City of Alachua

Planning & Community Development Department Staff Report

October 8, 2019

SUBJECT:	A request for consideration of the preliminary plat of Briarwood, which proposes the subdivision of a ±74.17 acre subject property into a total of 229 lots, with associated rights-of-way and common areas
APPLICANT:	Craig Rouhier, Troon Development, LLC
AGENT:	Dave Glunt, P.E., Spruce Creek Civil Engineering, Inc.
PROPERTY OWNER:	Golden Pond Farms, Inc.
PARCEL ID NUMBER:	03044-011-001, 03044-011-002, 03044-011-003, and 03044-010-003
FLUM DESIGNATION:	Moderate Density Residential
ZONING:	Residential Single Family -4 (RSF-4)
OVERLAY:	N/A
ACREAGE:	±74.17
PROJECT PLANNER:	Adam Hall, AICP
RECOMMENDATION:	Staff recommends that the Planning & Zoning Board transmit the preliminary plat of Briarwood to the City Commission with a recommendation to approve subject to the five (5) conditions provided in Exhibit "A" and located on page 19 of the Staff Report.
RECOMMENDED MOTION:	<i>Based upon the competent substantial evidence presented at this hearing, the presentation before this Board, and Staff's recommendation, this Board finds the application to be consistent with the City of Alachua Compre

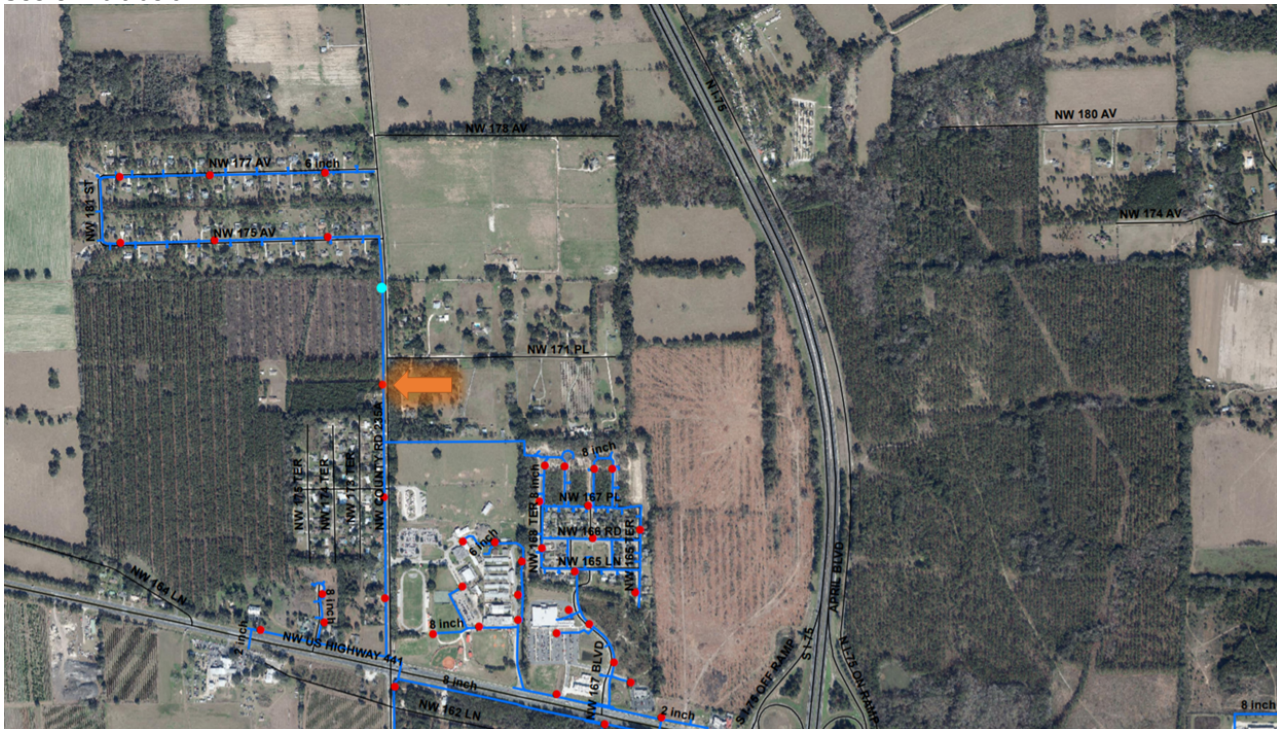
Following up on our conversation from last week regarding the City fire flow capability near the Briarwood development, City has performed an assessment for the fire flow at the hydrant along 235A. See exhibit below.
